Barangaroo South - Stage 1a Public Domain Works Excavation Works (SSD 6303), Hickson Road, Millers Point

2 September 2014

**Re: Barangaroo South - Stage 1a Public Domain Excavation Works (SSD 6303),
Hickson Road, Millers Point**

Title				
WATERFRONT PROMENADE				
Drawn By	Date	Checked By	Approved By	Date
BK/J/N/P	11.02.2014	AL	RJ/SC	26.08.2014
Scale:				
1:50 @ A1				
1:100 @ A3				
Project No.	Site No.	Drawing No.	Revision	
161803	B10	LD5500010	04

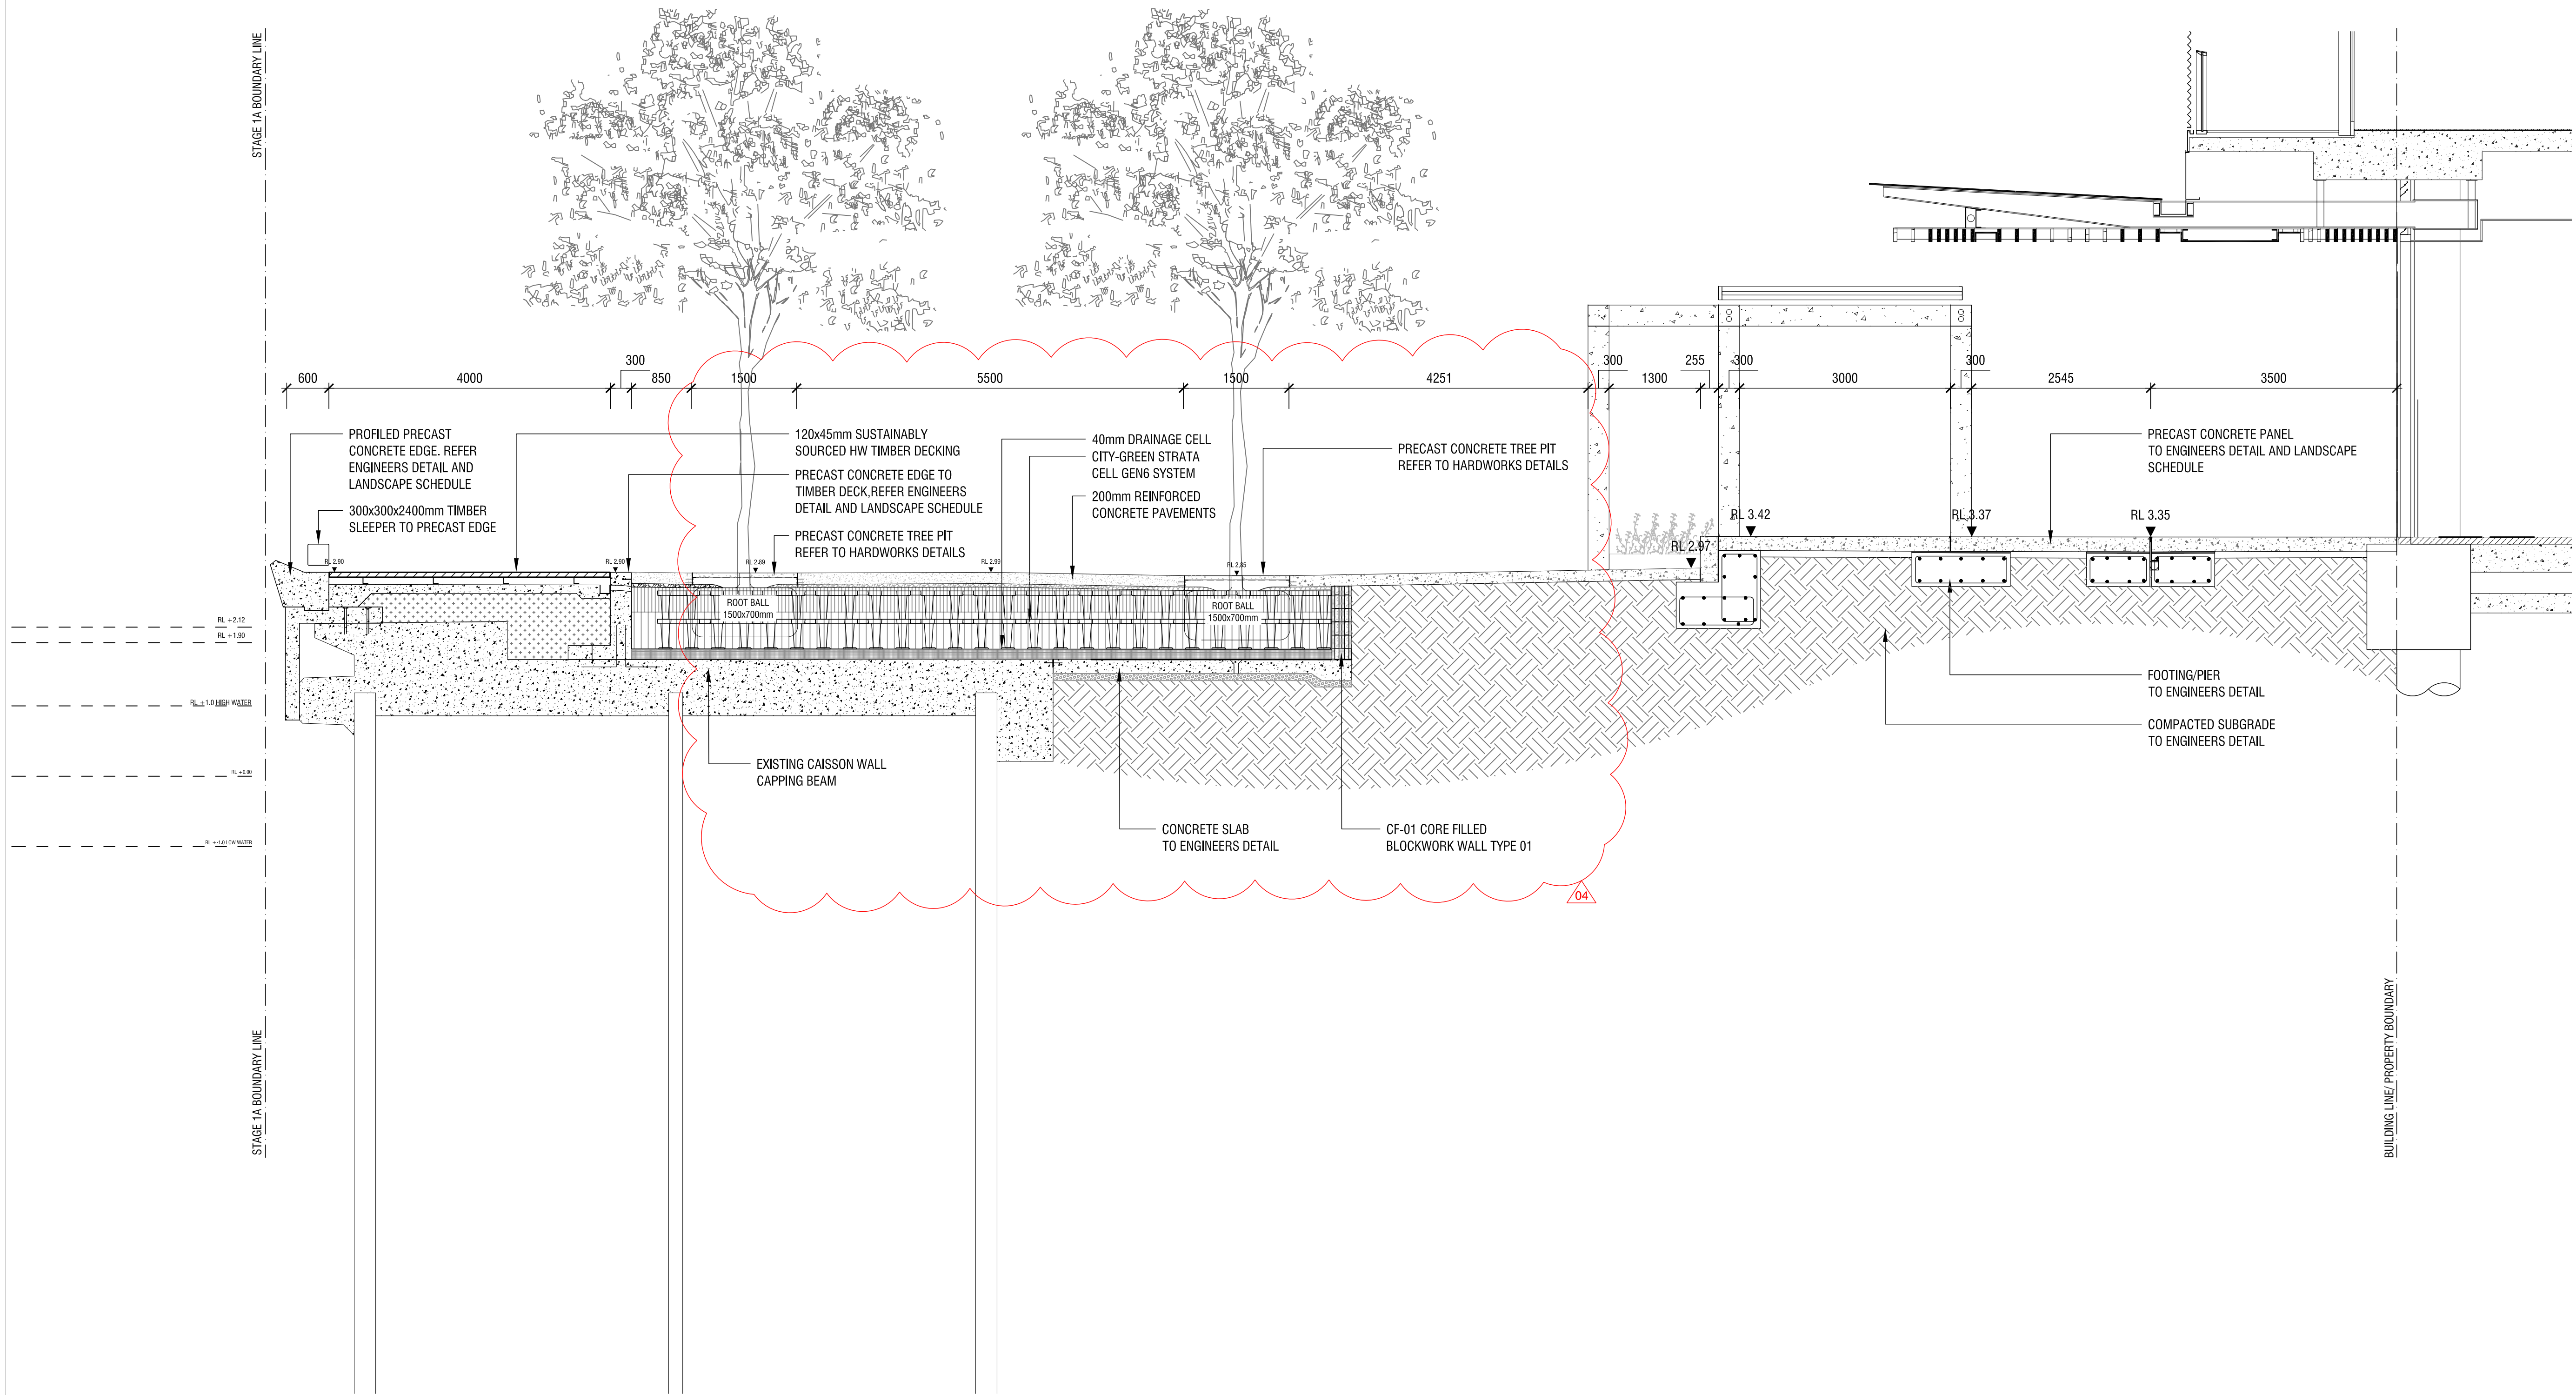
- The continuous planter box will be capped with a concrete slab (refer to **Figure 1**) limiting the potential for future contact by future land users with the underlying soils (i.e. the general public using the ORWS Public Domain);

- The width of the bulk excavation works will extend approximately 28 m east from the harbour;
- The proposed finished surface level of the continuous planter box will be approximately 2.85 - 2.90 m AHD (refer to **Figure 1**). On this basis, approximately 1.0 m of fill will be placed within the continuous planter box as a growing medium for the trees;

As discussed in **Section 3.0**, shallow excavation works will be required to facilitate construction of the proposed continuous planter box as shown in **Figure 1**.

Figure 2

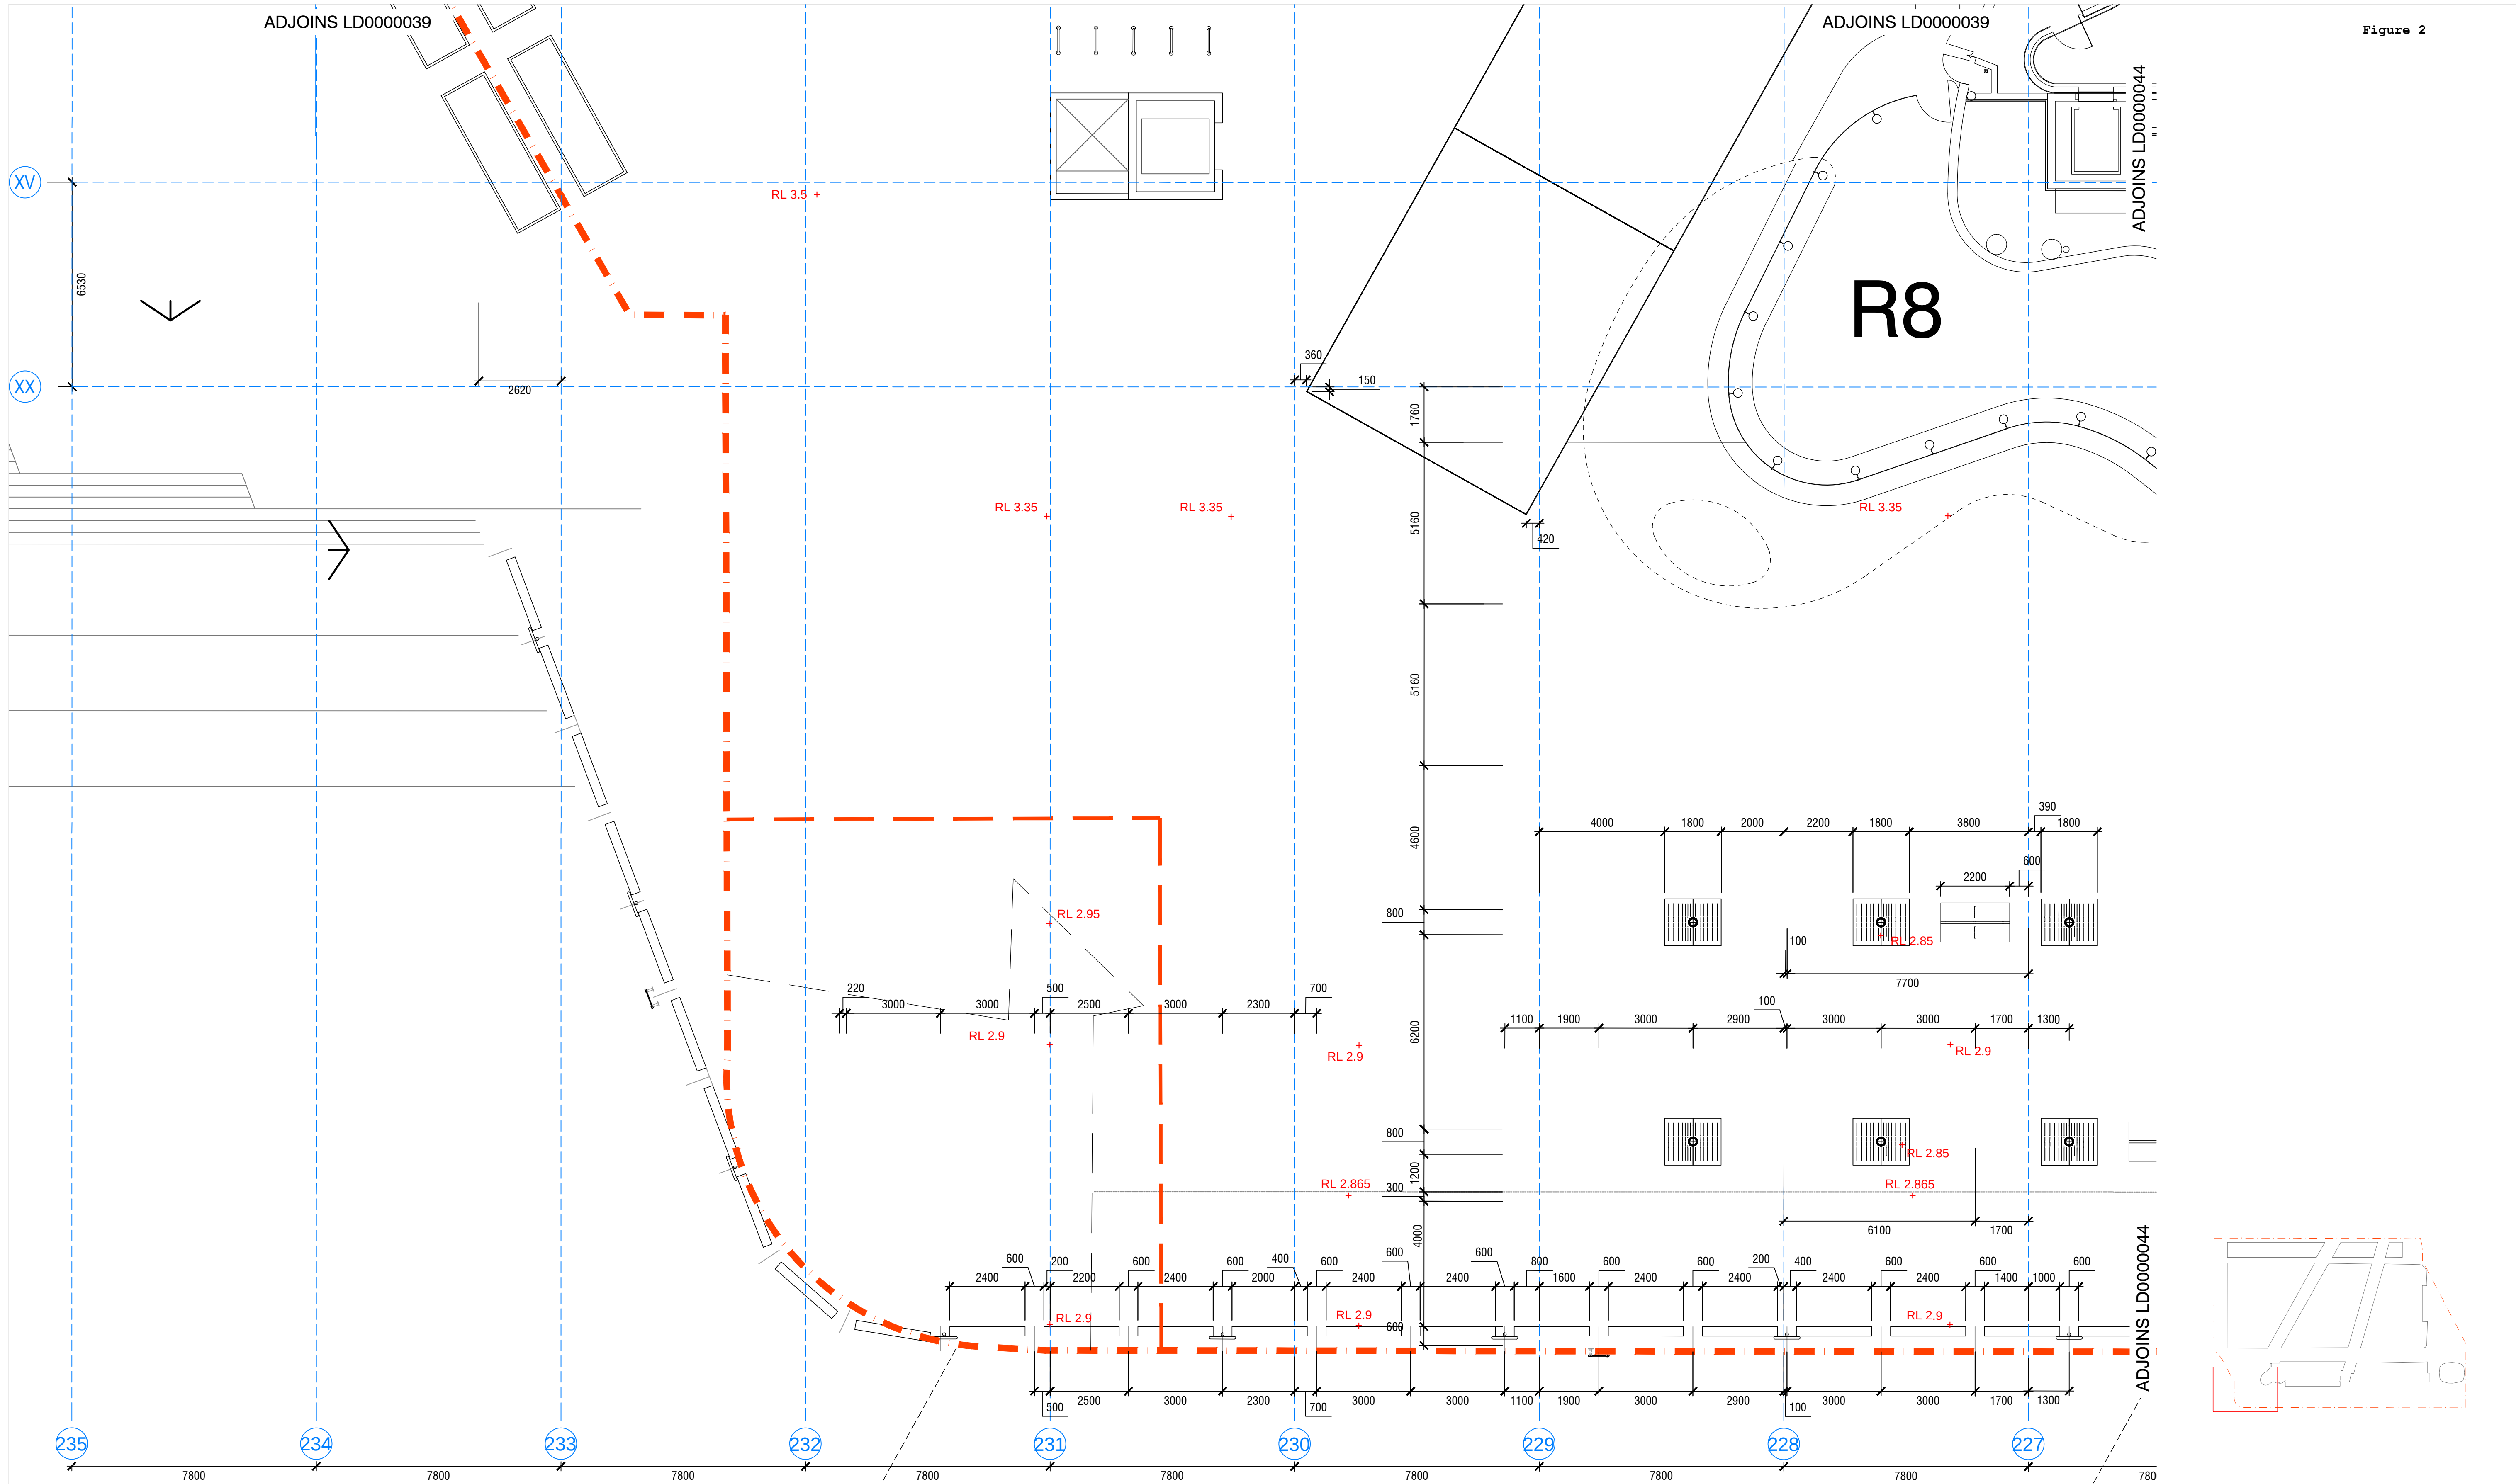
- The continuous planter box will be used to provide appropriate growing media for two rows of trees planted along most of the western extent of the ORWS Public Domain (refer to **Figure 2 to 5**);

Figure 6

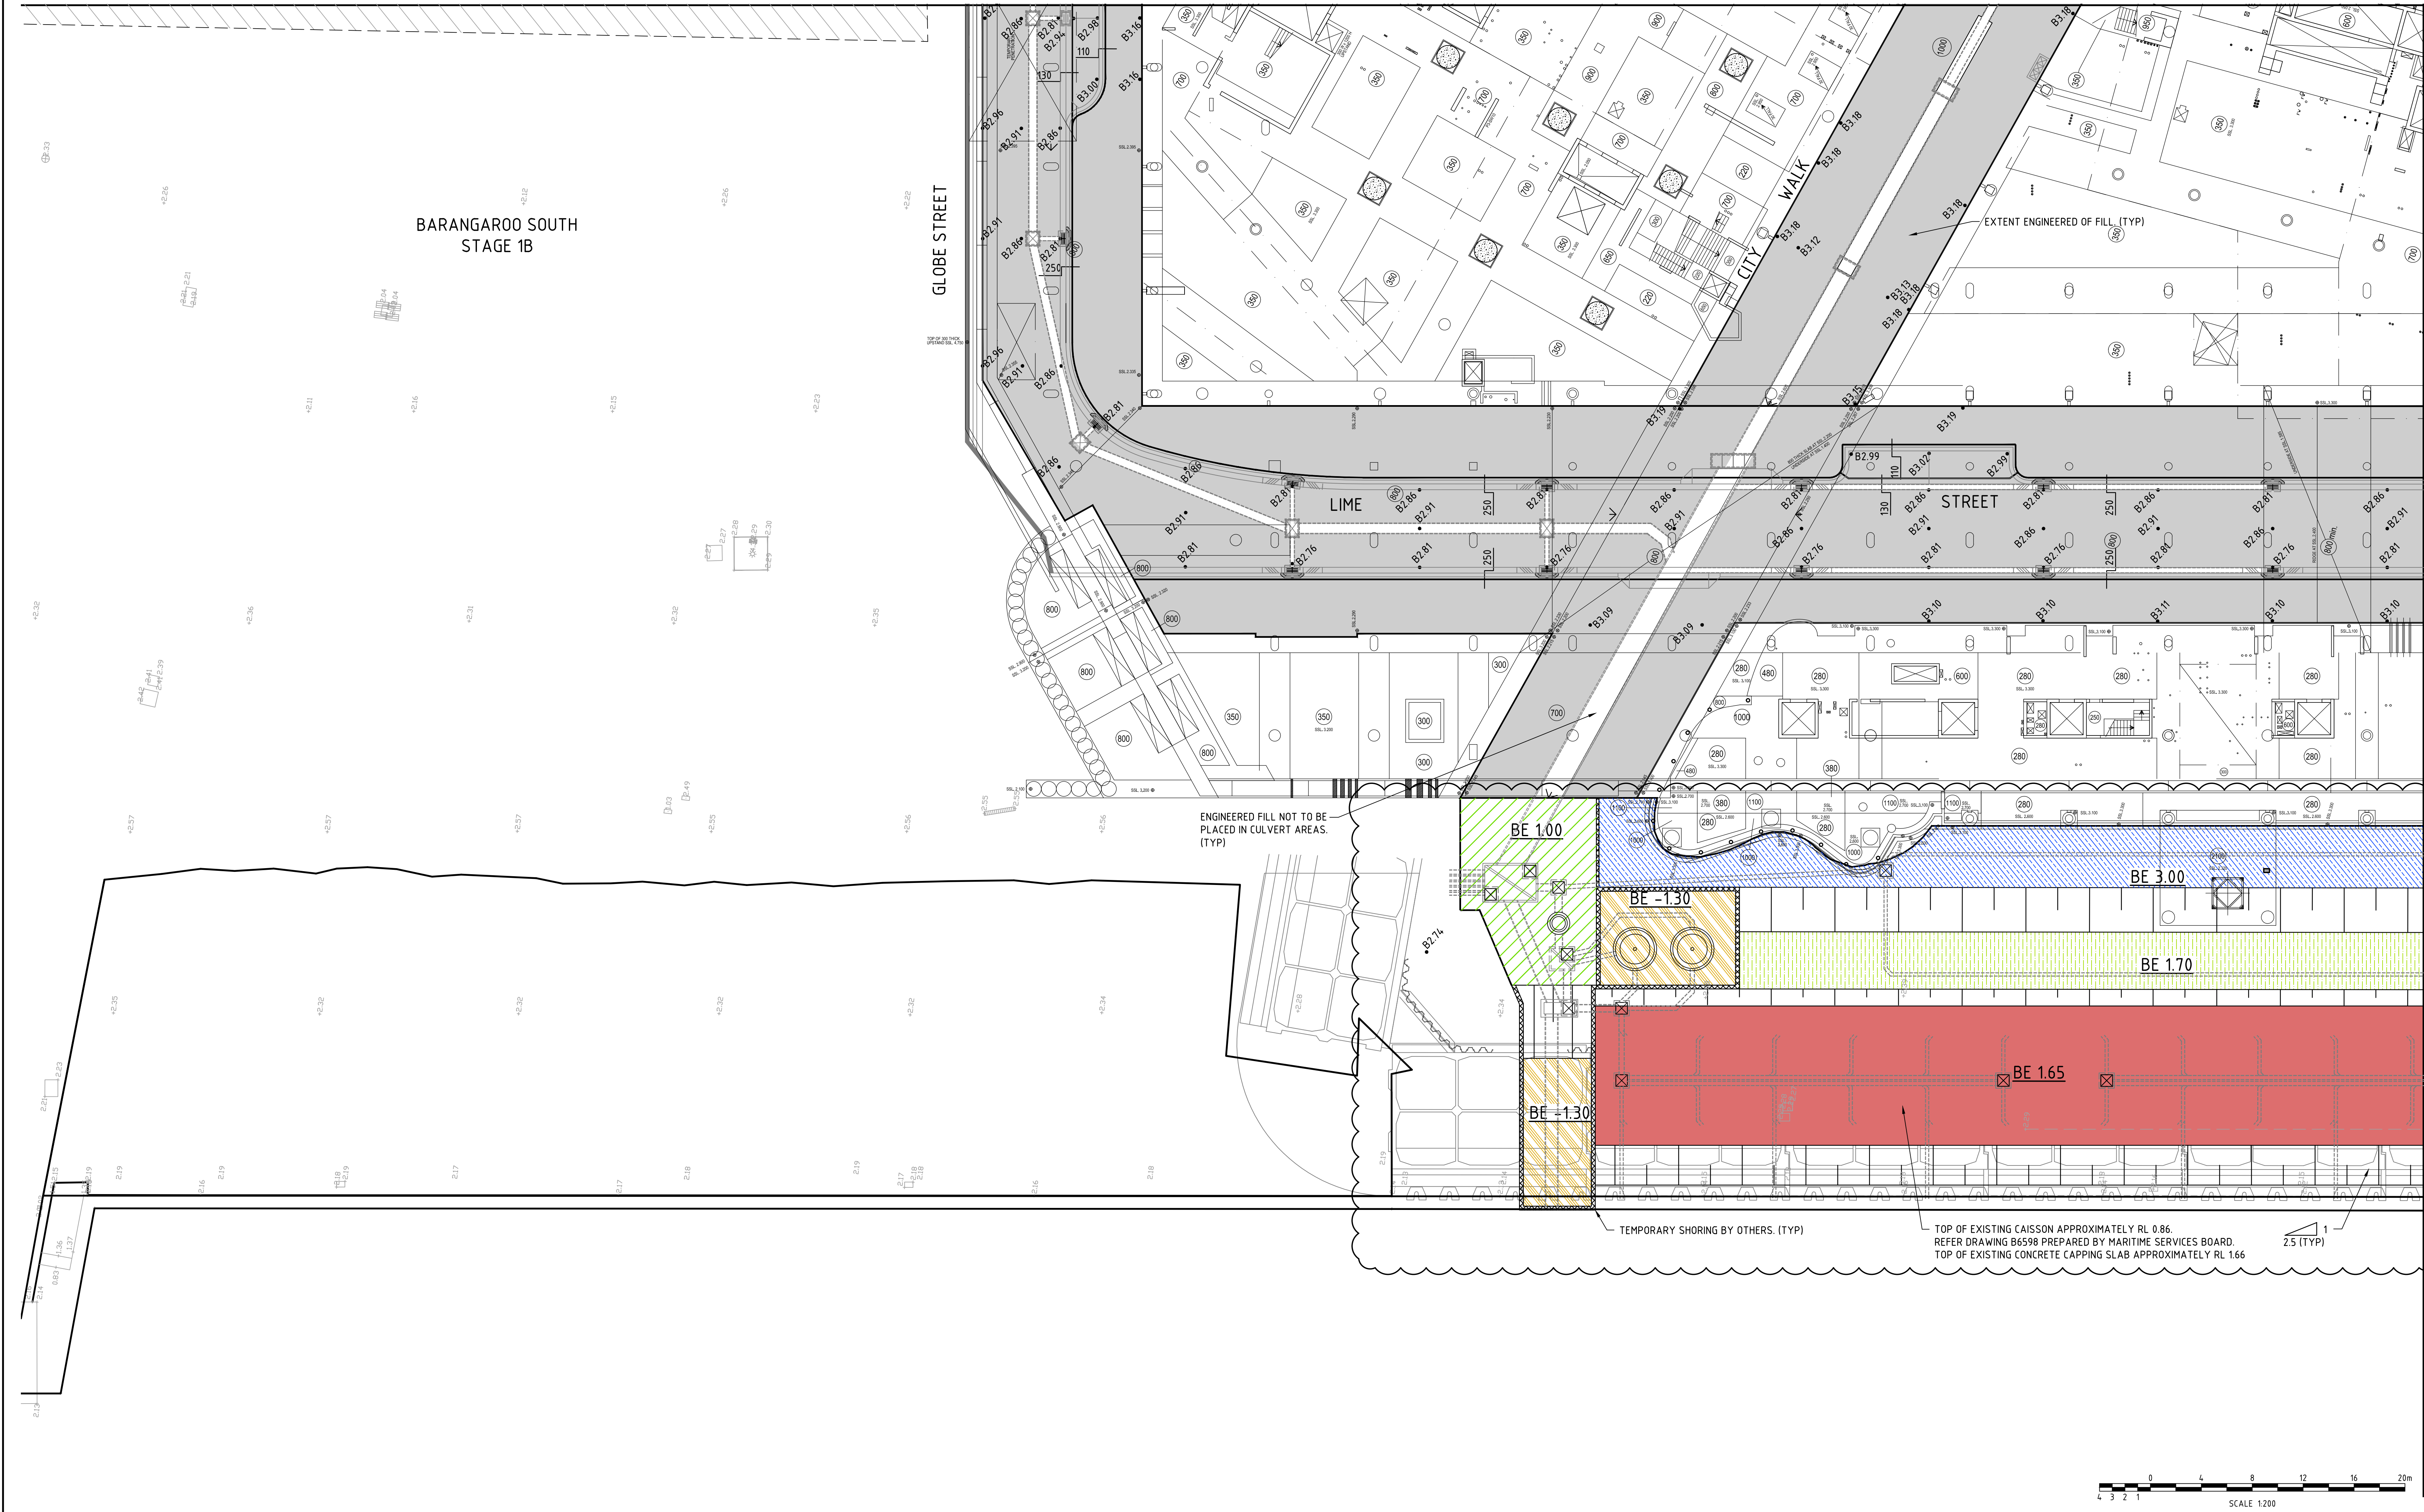
This letter has been prepared by AECOM Australia Pty Limited (AECOM) for Lend Lease Pty Ltd to support the State Significant Development (SSD) 6303 works being completed in the Stage 1a Public Domain. The footprint of the Site is shown on the attached **Figure 6** (denoted by dashed red line).

The proposed Stage 1a Public Domain development is shown on Attachment 1. The excavation works referred to in the AECOM letter are to the west of the groundwater retention wall shown as the Waterfront Promenade on Attachment 1.
